**RE: Hanson Aggregates Pennsylvania LLC – Rock Hill Quarry
Permit Update – E&S Plan Certification
SMP No. 7974SM1
East Rockhill Township, Bucks County
EarthRes Project No. 061003.052**

**ATTACHMENT 1
POND CERTIFICATION FORMS
AS-BUILT CALCULATIONS
AS-BUILT SITE PLAN**

AS-BUILT SITE PLAN

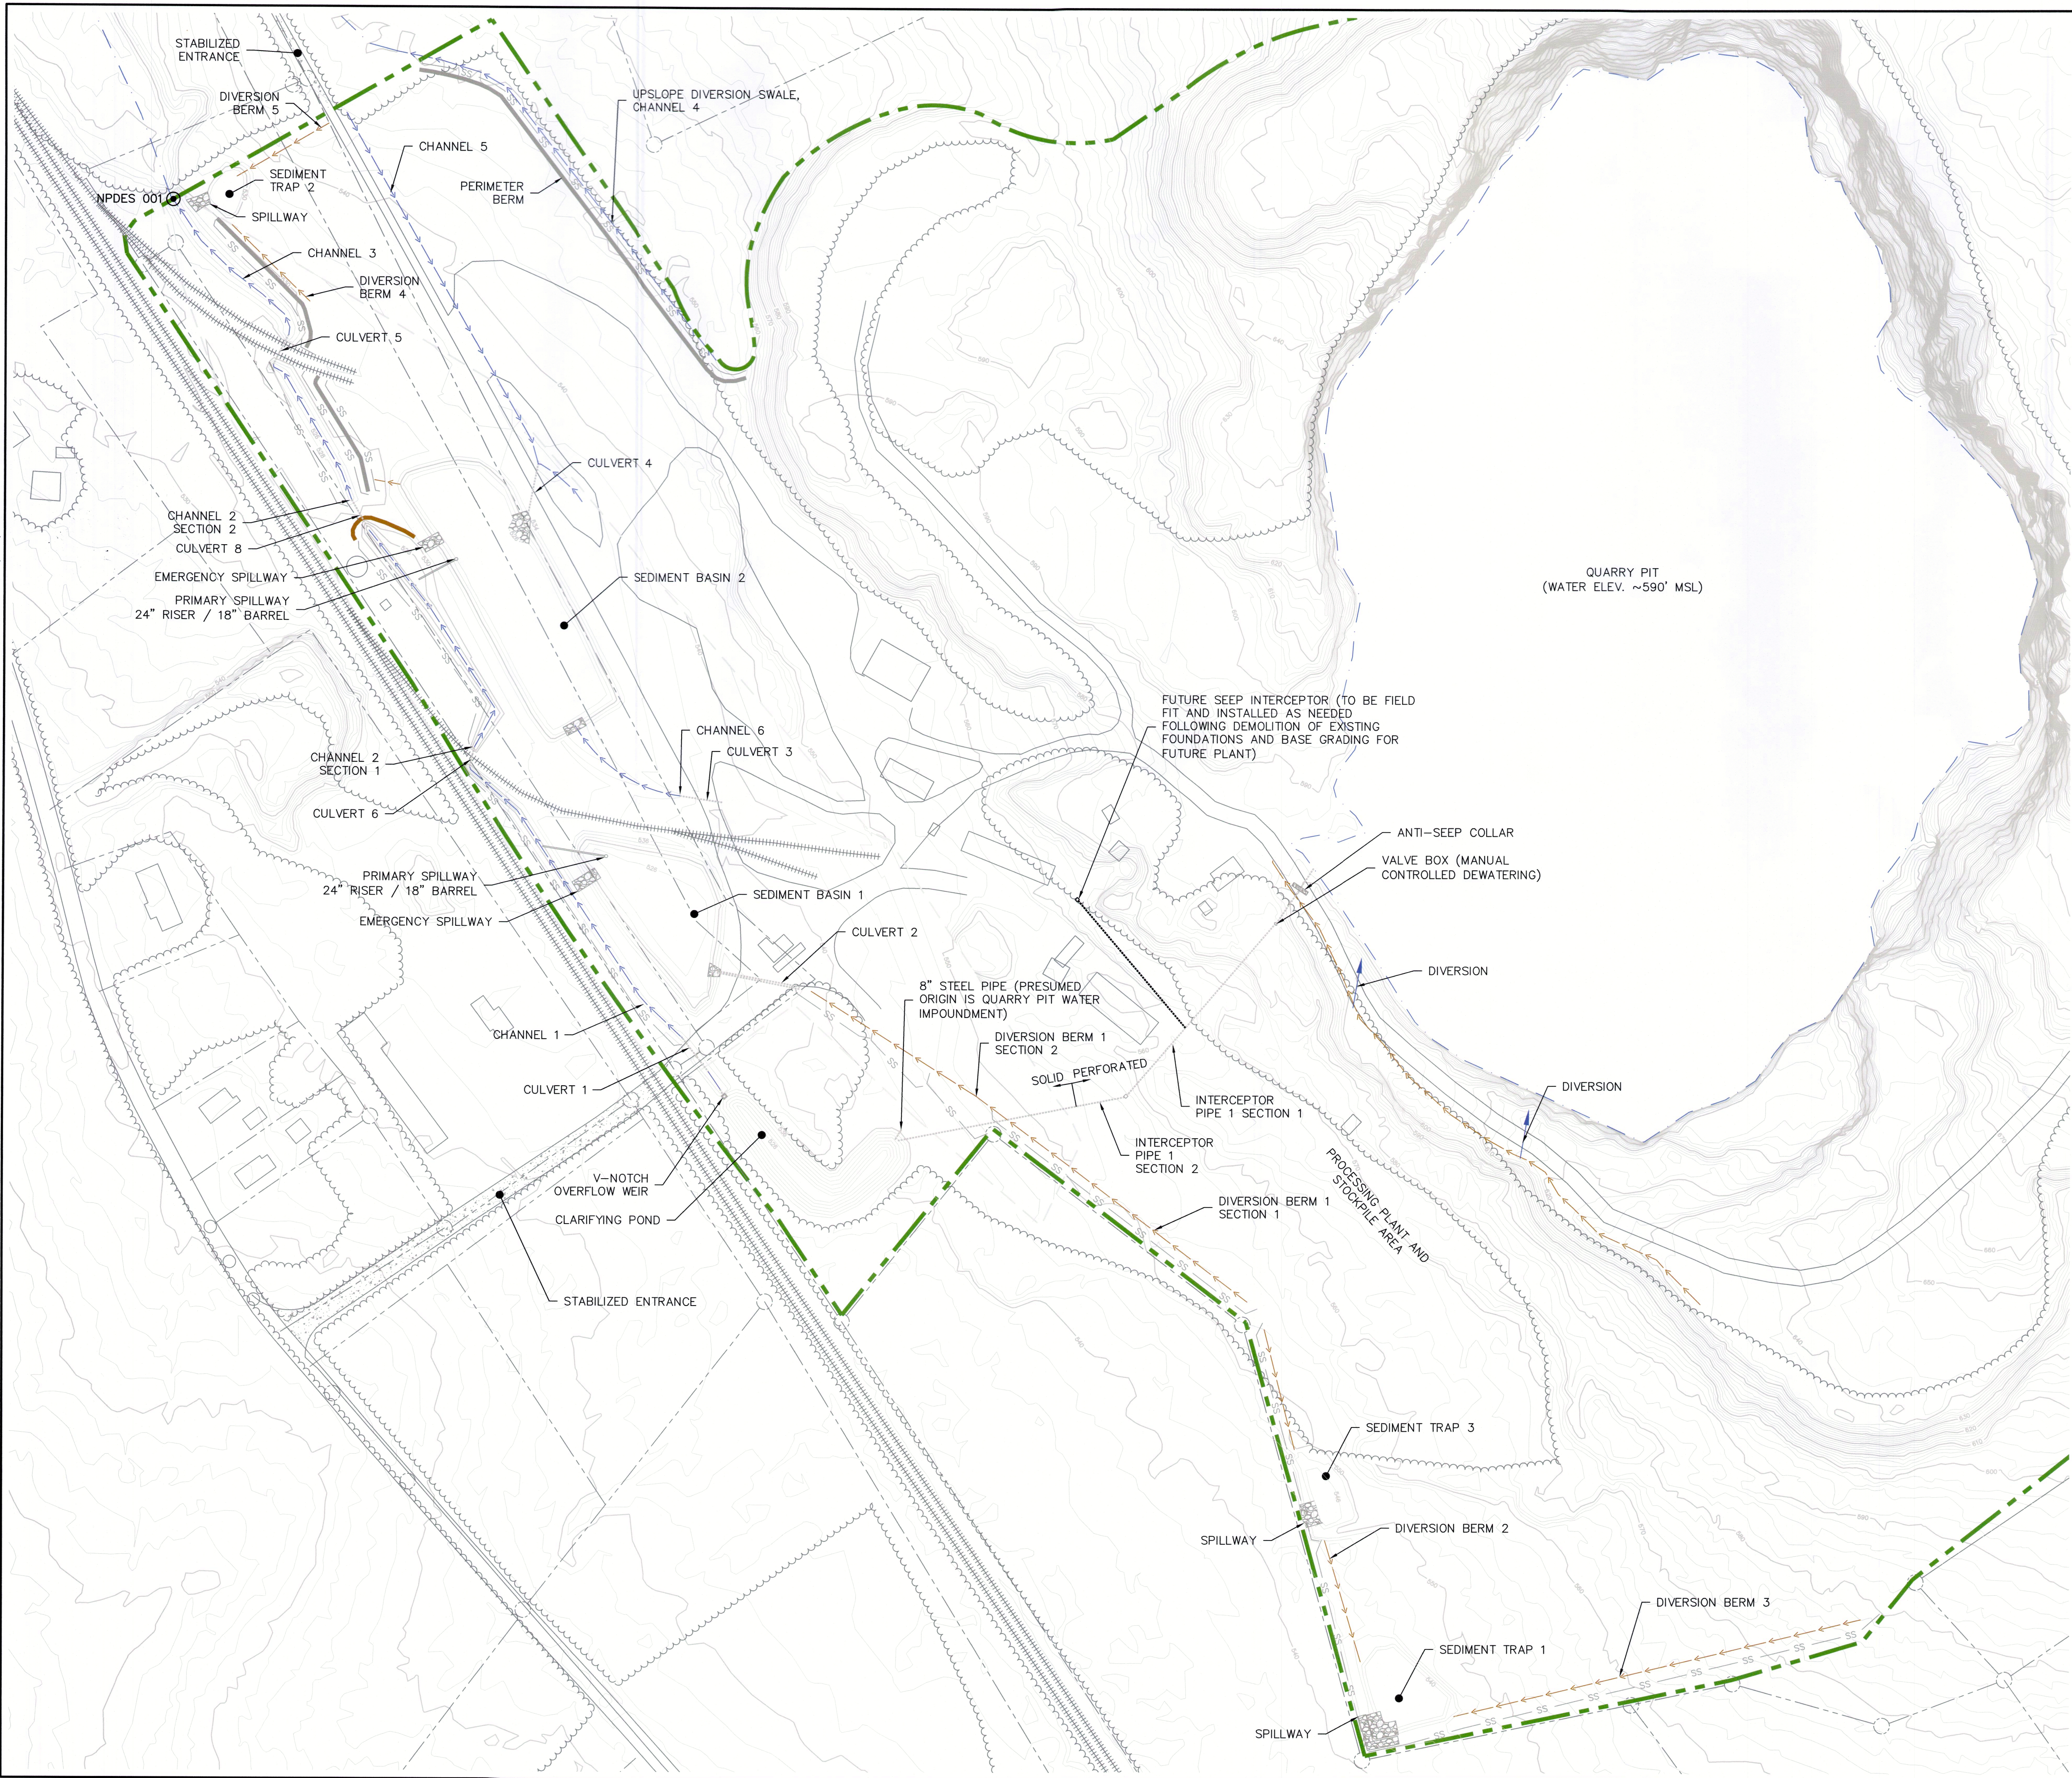
- **I will need the Pond Cert. sheets (13-3 & 13-4) for ALL impoundments (Clarifier Pond and Sed. Traps 1,2,3)**

- **Provide the following info. On sheet 13-3, as applicable:**
 - **Principle Spillway Inlet and Crest Elev.'s**
 - **Principle Spillway Capacity with 2' Freeboard remaining (in cfs)**
 - **Emergency Spillway Capacity with 2' Freeboard remaining**
 - **Volume @ Principle Spillway Crest**

- **Indicate that the Clarifier Pond Outlet will be adjusted as necessary to provide a minimum 6hr Det. Time (+sludge factor) at design/field flow. Also address the source of the existing pipes outletting into the Clarifier pond observed on my last site visit. This can be added as a narrative to the Clarifier Cert.**

- **Indicate that all channels/berms have been constructed and completed as designed.**

- **Indicate with the Sed. Trap Cert.'s any deviations from the design (i.e. the outlet for Sed. Trap 2).**

Response: Pond Certification sheets have been included for all impoundments (Sediments Basins 1 and 2, Clarifying Pond, and Sediment Traps 1, 2, and 3). Refer to Attachment 1.

Response: The pond certification sheets have been modified to include the above requested information, as applicable. Refer to Attachment 1.

Response: A narrative description outlining the process for field adjustments to the Clarifying Pond outlet weir as well as a description of the origin of the inflow pipe has been included in Attachment 2.

Response: A summary description of all E&S Controls indicating that they have been constructed as designed is included in Attachment 3.

Response: A description of the deviation from the outlet design for Sediment Trap 2 is included within the E&S Controls description included in Attachment 3.

Traps were constructed larger than designed to provide additional sediment storage and settling time. The Sediment Trap 2 outlet was constructed with an overflow outlet as opposed to a filter embankment. The trap maintains a permanent pool of water within the sediment storage zone and is functioning without issue.
